Review of Plans: East Coast BLR Site Plan, 11 Kings Highway, Orangeburg, NY  
Section 74.11 Block 2 Lot 4 LIO zone

Subject: **East Coast BLR Site Plan**  
Prepreliminary/ Preliminary/ Site Plan  
and SEQRA Review  
11 Kings Highway, Orangeburg  
74.11-2-4; LIO

**PB #23-07: East Coast BLR Site Plan      Permit #BLDC-2053-22**  
**Preliminary Site Plan Approval Subject to Conditions**  
**Neg. Dec.**

**RE:    East Coast BLR Site Plan:** The application of Thota Nagaraja, applicant, for East Coast BLR, LLC, owner, for review of a site plan to be known as “**East Coast BLR Site Plan**”, in accordance with Article 16 of the Town Law of the State of New York, the Land Development Regulations of the Town of Orangetown, Chapter 21A of the Code of the Town of Orangetown and to determine the environmental significance of the application pursuant to the requirements of the New York State Environmental Quality Review Act. The site is located at 11 Kings Highway, Orangeburg, Town of Orangetown, Rockland County, New York, and as shown on the Orangetown Tax Map as Section 74.11, Block 2, Lot 4 in the LIO zoning district.

**PROPOSED SITE PLAN**

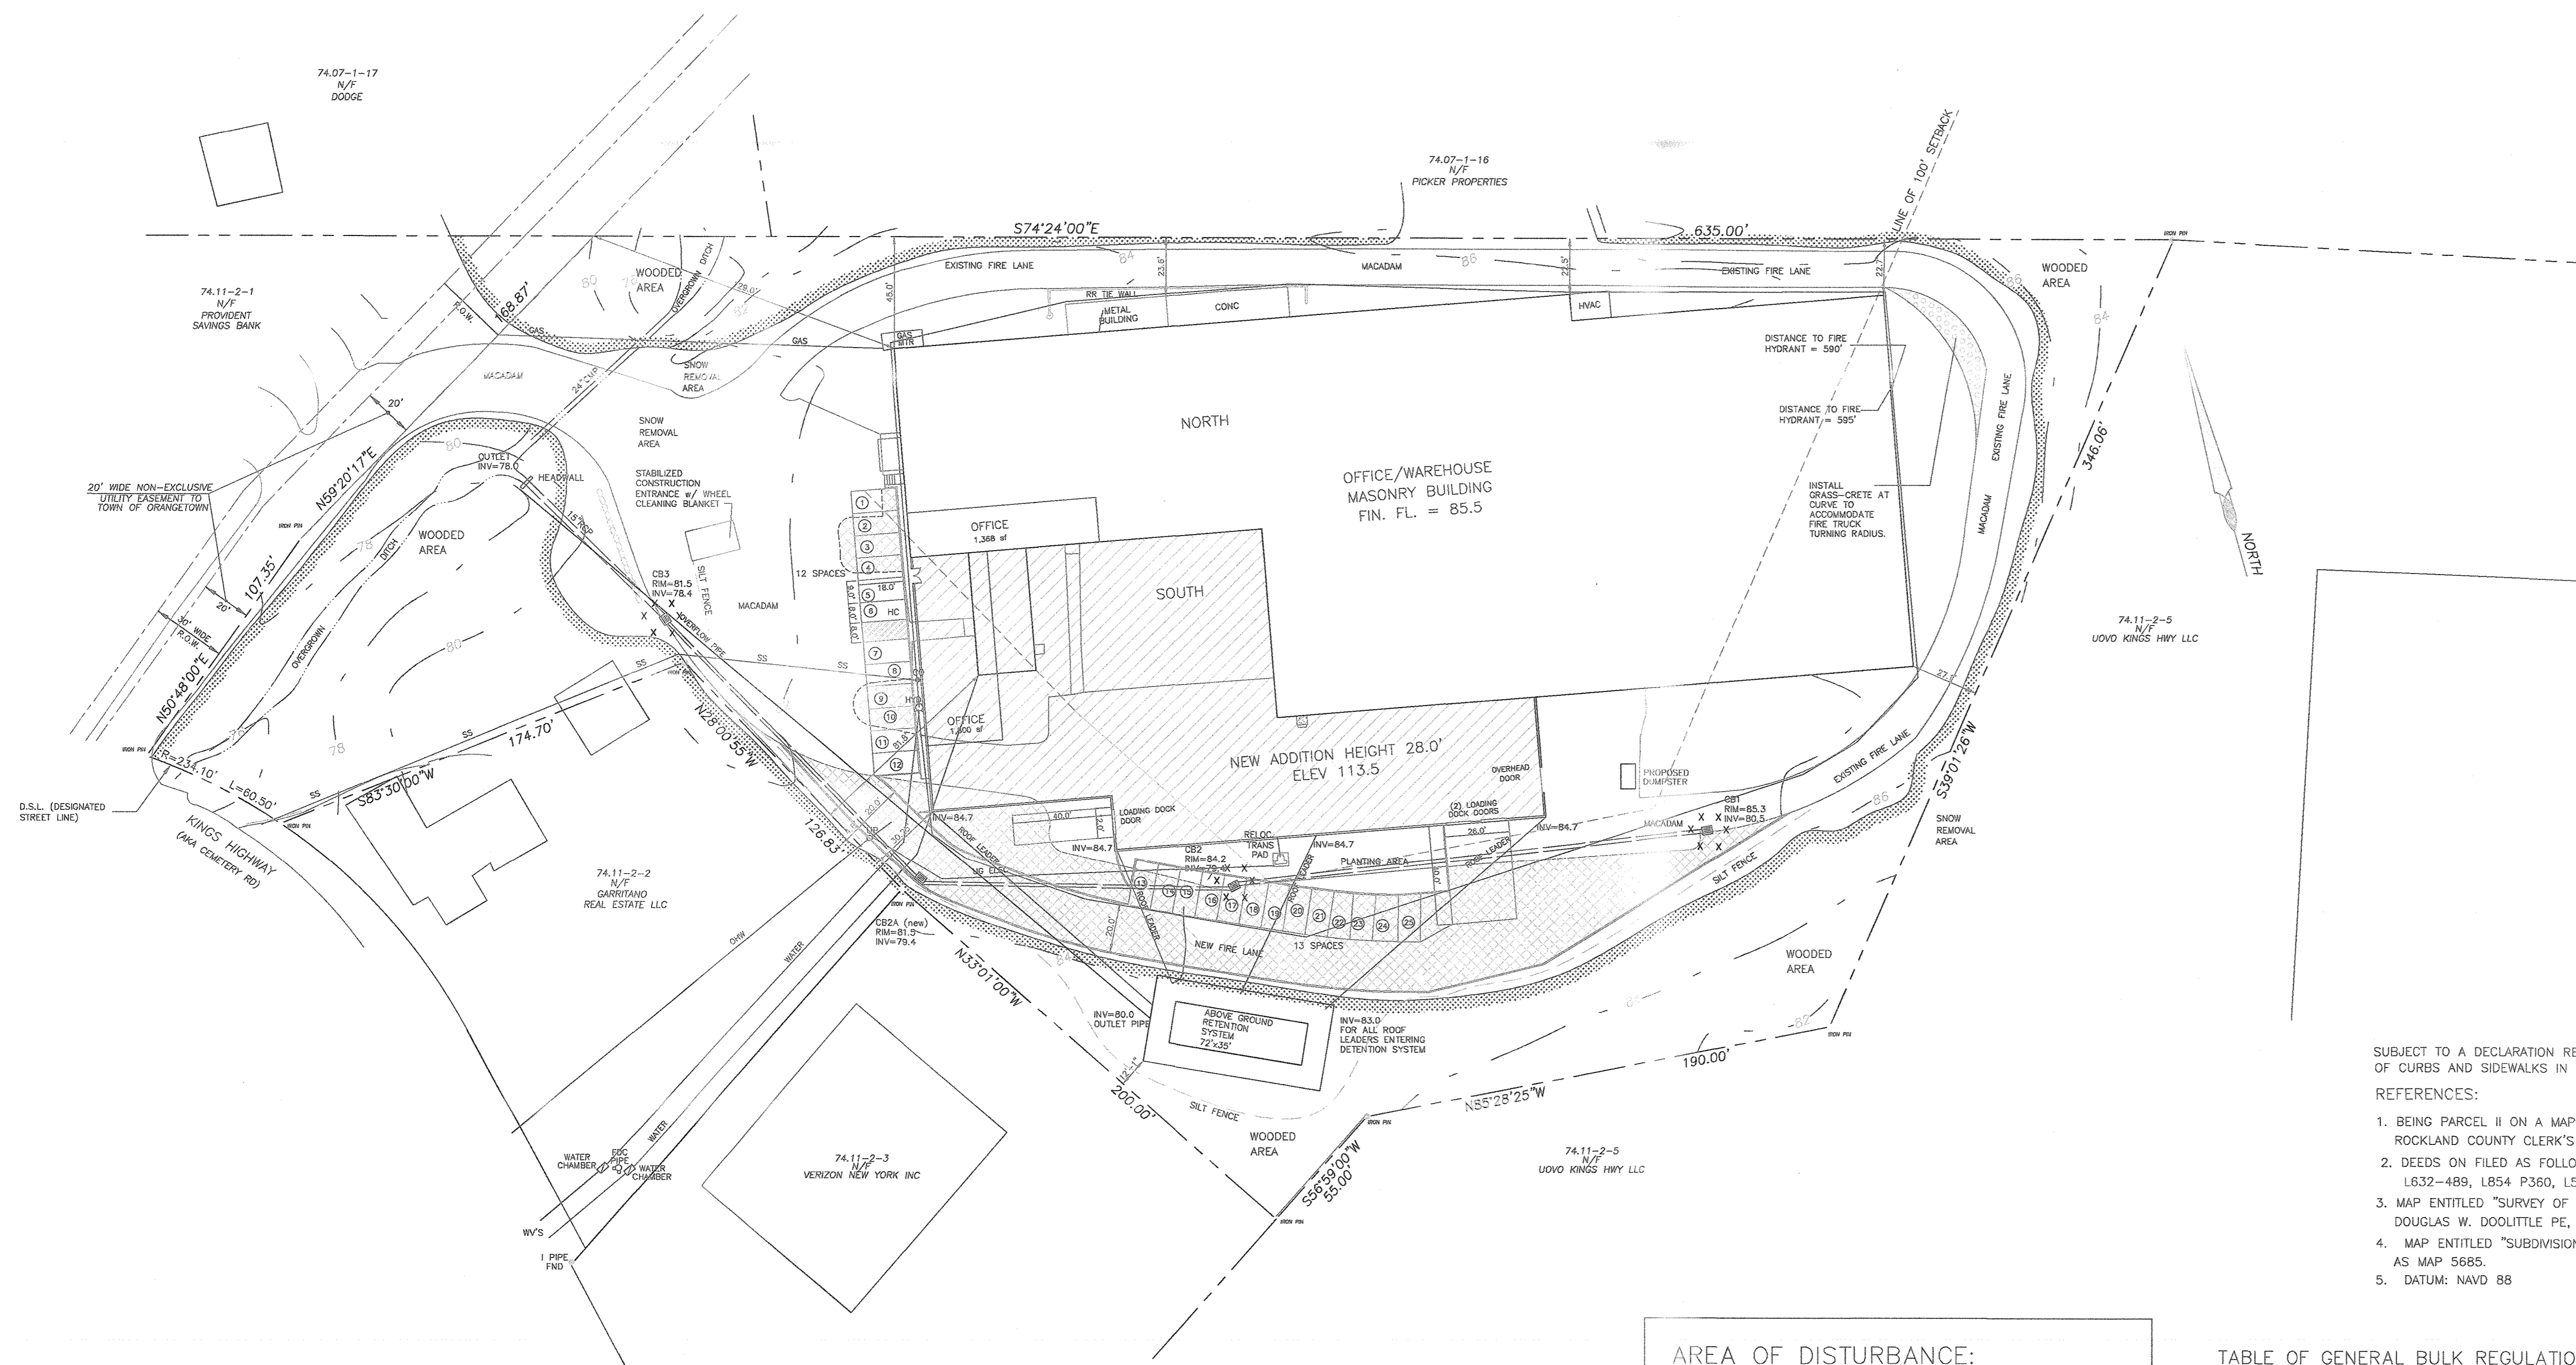
- 1) The property lines and the required setback lines should be more clearly delineated with thicker line weights.
- 2) Per Chapter 43, Table 3.11, column 4, Conditional Uses by Planning Board, number 4, "Light Manufacturing uses, subject to performance standards procedure, 4.12." IUC review and approval is required.

- 3) Per Chapter 43, the following variances are required;
  - a. Table 3.11, LIO District, Column 7, Additional Use Regulations; #2, same as LO, Column 7, #2 "all accessory off-street loading berths shall be within completely enclosed buildings, and in addition:"

- b. Table 3.12, LIO district, Column 9, side yard required is 100' with 30.25' proposed
  - c. Table 3.12, LIO district, Column 10, total side yard required is 200' with 57.4' proposed.

- 4) Per Chapter 43, table 3.11, LIO District, Column 7, #3, "No parking is permitted in any required yard, unless permitted by any board or town agency having jurisdiction. This permission may be given at the time of site review..." Parking is proposed in the south required side yard.

8. Per Chapter 43, Article VI, Section 6.34, Size of spaces and aisle width. "Aisle width shall not be less than 22' for 90 Degree parking with 20' proposed. Plans must be revised to meet code.

**14.** The plans depict a rectangular above ground stormwater management facility, with multiple contributing drainage pipes entering the basin at varying location. The shape and structural layout of the proposed basin does not meet the design standards set forth in the NYS-SMDM. The basin sized and designed in accordance with the required design calculations and the NYS-SMDM

**15.** A "blow-up" of the proposed stormwater basin shall be provided on the drawings. Cross-sections, storage volume for given design storms and elevations, 25-foot pond buffer, 12-foot-wide stabilized maintenance path (that reach the forebay/ main pool/outlet structure/ emergency spillway, flared end inlets, etc.), outlet structure, pond drain valve, permanent sediment depth marker with detail, plantings (if utilized for water quality control), emergency overflow spillway with elevations, etc.

21. It appears that none of the new paved areas are draining into the proposed stormwater basin. The drawings shall be revised to show stormwater runoff from these areas entering the basin.

42. It appears that the entrance to the site is through another property. IF an access easement exists for this site across Lot 74.11-2-1 (N/F Provident Savings Bank), it shall be show on the drawings, along with the filing information and the metes and bounds.

8. Coordinate the line types using for the existing contours. Add a legend for the proposed grading plan distinguishing existing and proposed contours. It appears the detention basin is missing an additional elevation 84 contour on the north side of the basin.

9. Provide proposed grading that shows the proposed storm drainage invert of 84.7 on the south side of the addition will not be above grade.
  10. Use different symbols to distinguish between existing and proposed storm drainage pipes and catch basins.

11. Coordinate the orifice size on the Outlet Structure Detail. Show the Outlet Structure on the Drainage Plan.
  12. Clarify the difference between Drainage Area 1 and Drainage Area 2 on the Drainage Plans. The drainage areas should be determined by site topography and specific hydrologic features.
